**DOCUMENT 00 90 10**  
**ADDENDUM No. 1**

- A. The Construction Contract is known as:  
SA009 – CIP – 12TH ST/CENTURY DR – PHASE 1
- B. Date of this Addendum: 2/10/2026

SA009 – CIP – 12TH ST/CENTURY DR – PHASE 1

PP6

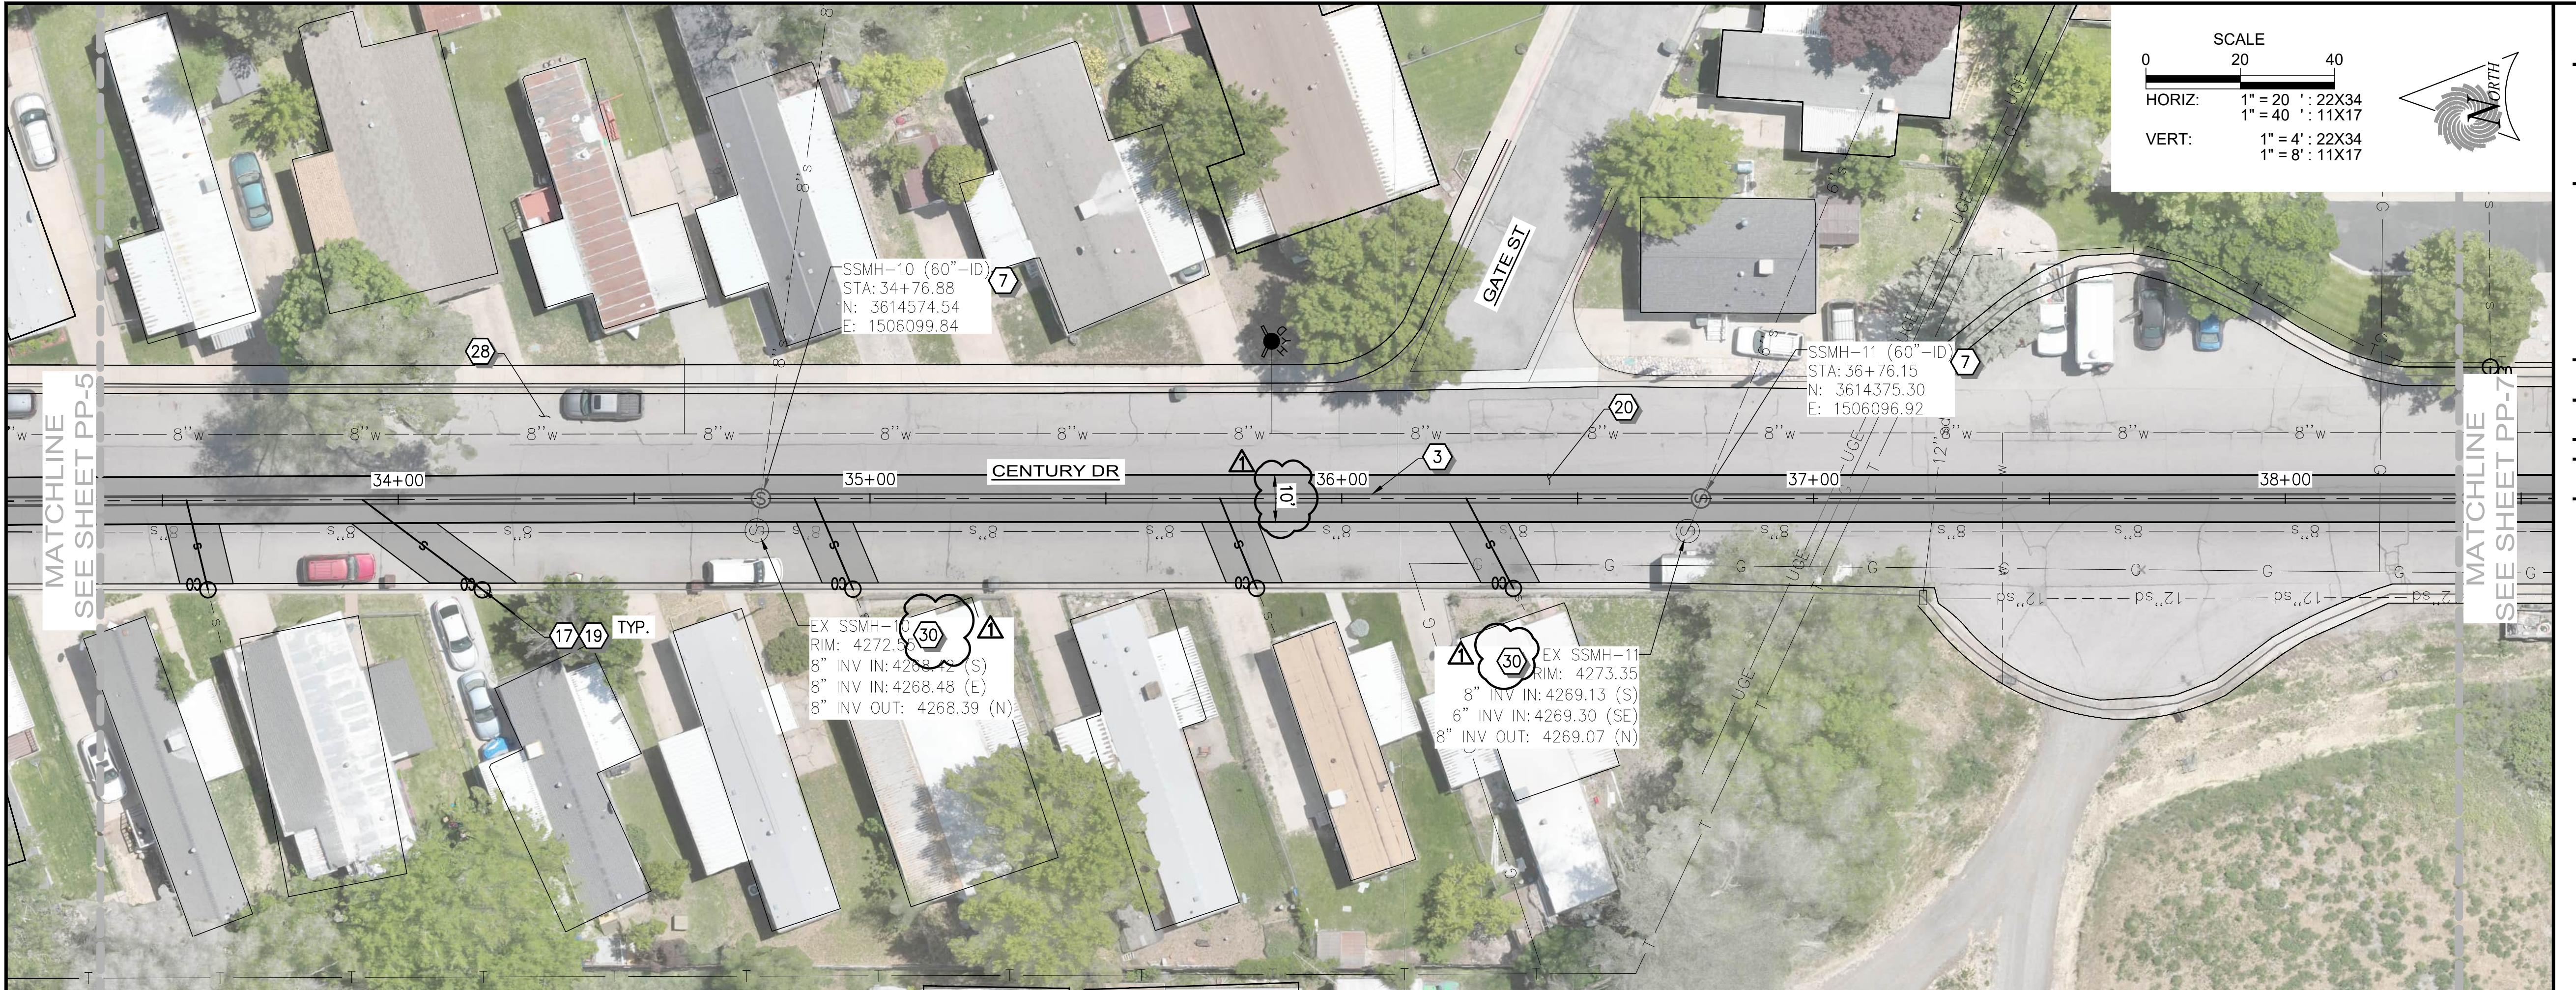
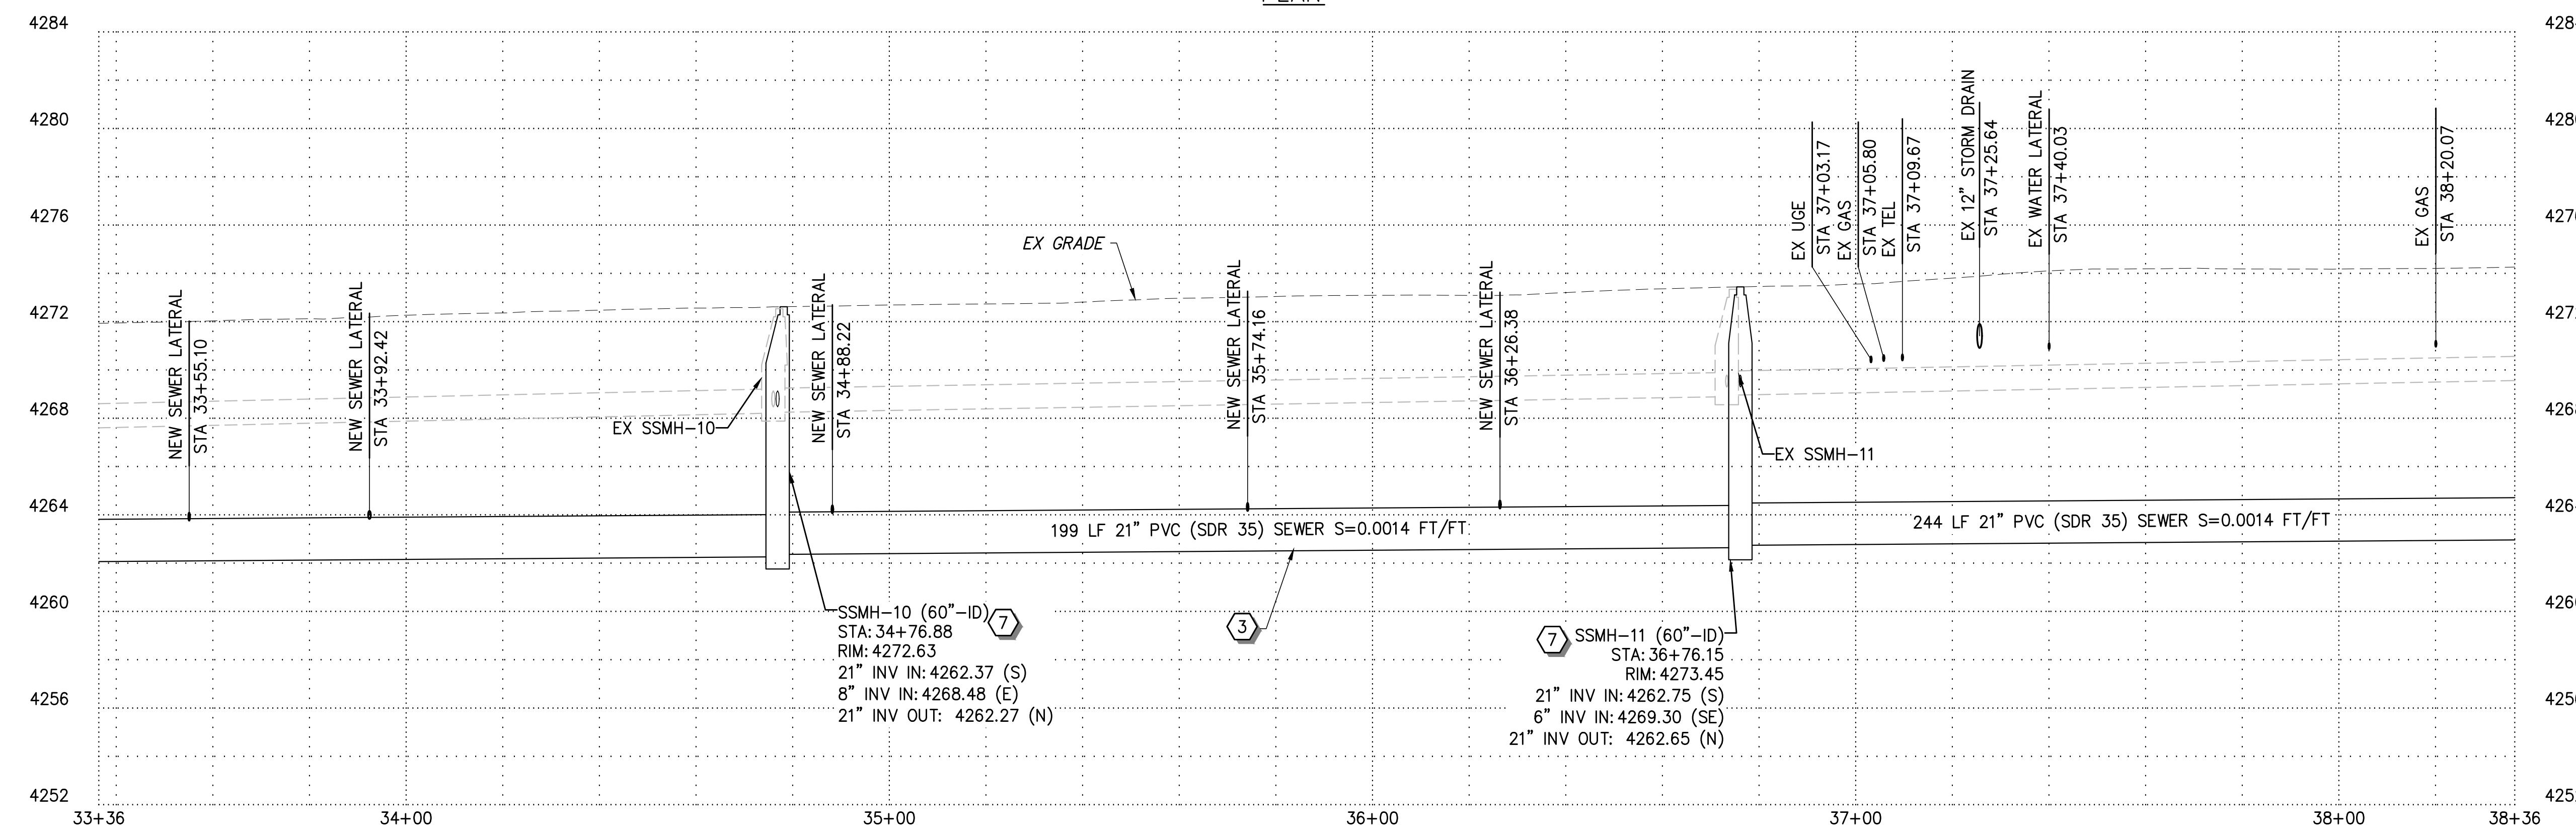
- D. Sheet PP2: Added label with rim and invert information for SSMH-4
- E. Sheet PP4: Added note for flow fill around the Mill Creek Irrigation boxes, including dimensions.
- F. Sheet PP6: Updated keynotes to raise and collar instead of abandon manholes on EX SSMH-10 and EX SSMH-11.
- G. Sheet C1: adjusted dimensions that were not showing proper distances in the profile view, also added the water valve symbols to the plan view.
